**Tender 2010-42
Retaining wall Reconstruction
ADDENDUM #1**

Issued Date: Friday, August 13, 2010

SECTION 4 – RETAINING WALL AT 335 LAUREL STREET (PROVISIONAL)

355 LAUREL STREET RETAINING WALL

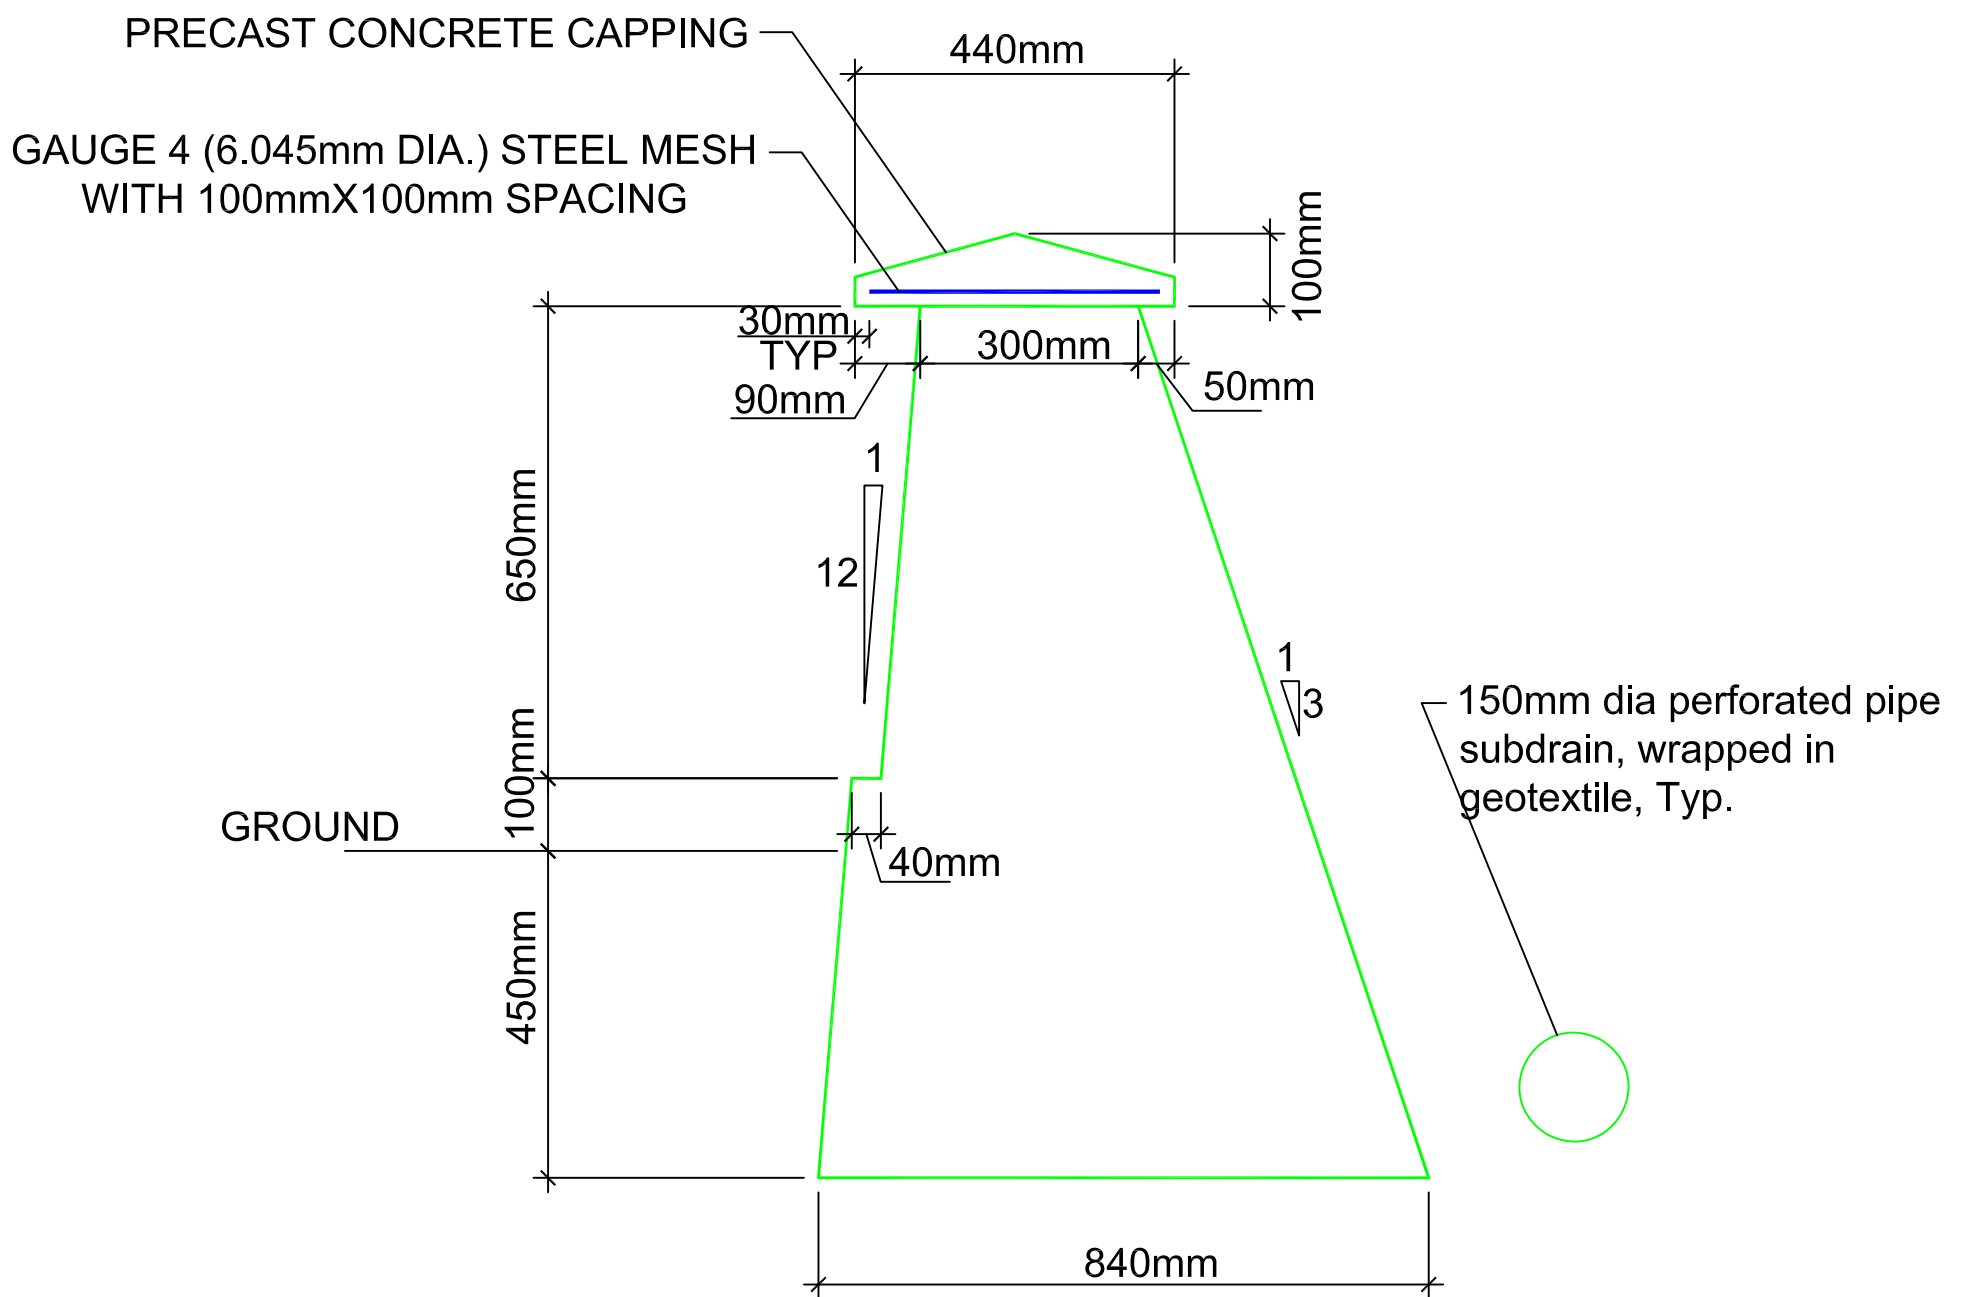
SECTION 'C', FORM OF TENDER – Section 4 to be added as follows:

For the unit bid price the Contractor shall provide all labour, equipment and material required to construct the following retaining wall and associated works as per Contract Specifications and Drawings.

For the unit bid price the Contractor shall supply and construct concrete toe wall as per the contract specifications and drawings and OPSD 3120.100. All costs for excavation, dewatering, backfilling, bedding, compacting, disposing of excess and/or unsuitable excavated material to a dumpsite, supporting and maintaining existing utilities, reinstatement of working areas and clean up as required, shall be included in the unit bid price.

The Contractor shall include all costs to:

Supply, place and compact 200mm granular 'A' base

Supply and install 150mm diameter perforated pipe subdrain, wrapped in geotextile.

For the unit bid price the Contractor shall supply and install precast concrete capping as per the contract specifications and drawings. All costs for attaching the capping to the toe wall shall be included in the unit bid price.

The concrete for making precast capping shall have a minimum strength of 30Mpa with maximum aggregates size of 10mm.
